Flood Risk Assessment

Lake Lane, Barnham, Bognor Regis PO22 0AJ

Ref: 12188

Application Reference:	WA/20/24/PL	Reviewer Reference:	ADC/SB
Planning Officer:	Simon Davis	Date of Review:	01/05/2024
Site Name:	Land to the North of Lake Lane Barnham PO22 0AJ		
Application Description:	Demolition of stable block and erection of 7 No. dwelling houses comprising 2 No. three-bedroom detached bungalows & 5 No. four-bedroom two storey detached houses together with associated car parking and landscaping. This application is a Departure from the Development Plan, falls partly in both Barnham and Walberton Parishes, is in CIL Zone 3, and is liable for CIL as new dwellings.		
Assessment Number:	1 of 1

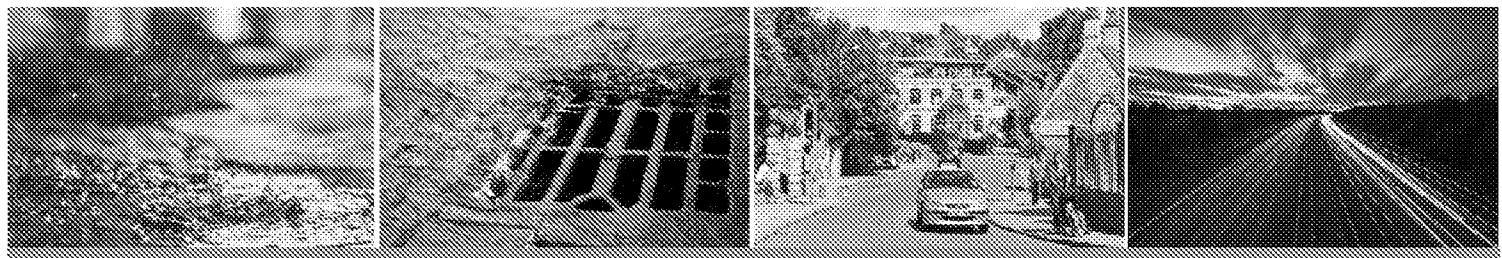
1. Updated site plans and layout accurately showing watercourse locations and their 3m easements as described above.
Watercourse locations clearly shown with the 3m easement
